QUATTRO

Newsletter 01-25

- Mandatory service bulletin

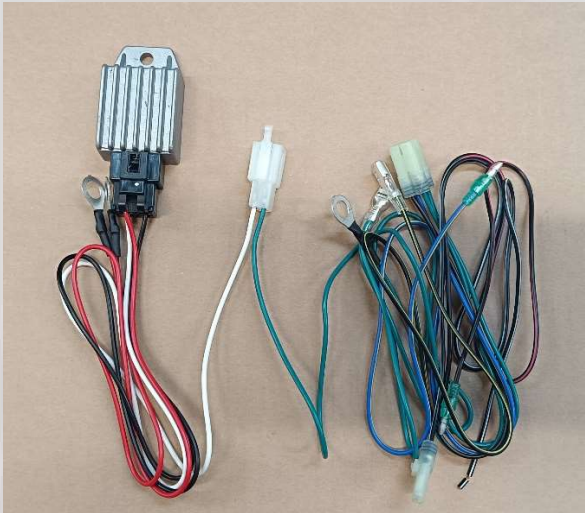
The QUATTRO generator can be damaged by incorrect wiring installation – Please pay attention to the following information:

- It is important to connect the battery negative to the engine ground when using a battery.
- The yellow cable can cause short circuit to the stator/generator when the engine is running. Users must remove the yellow wire from the connector. Please use a simple shrink wrap or something similar to protect the open end and prevent contact.

If no battery charging is installed, the rectifier does not need to be installed.

- The engine wiring is delivered as shown in the image below – to the left of the white connector is rectifier, used to to charge the battery. On the right side of the connector is the ignition system wiring harness.

- If you don't wish to charge the battery you can disconnect the white cable from the connector and discard the rectifier.
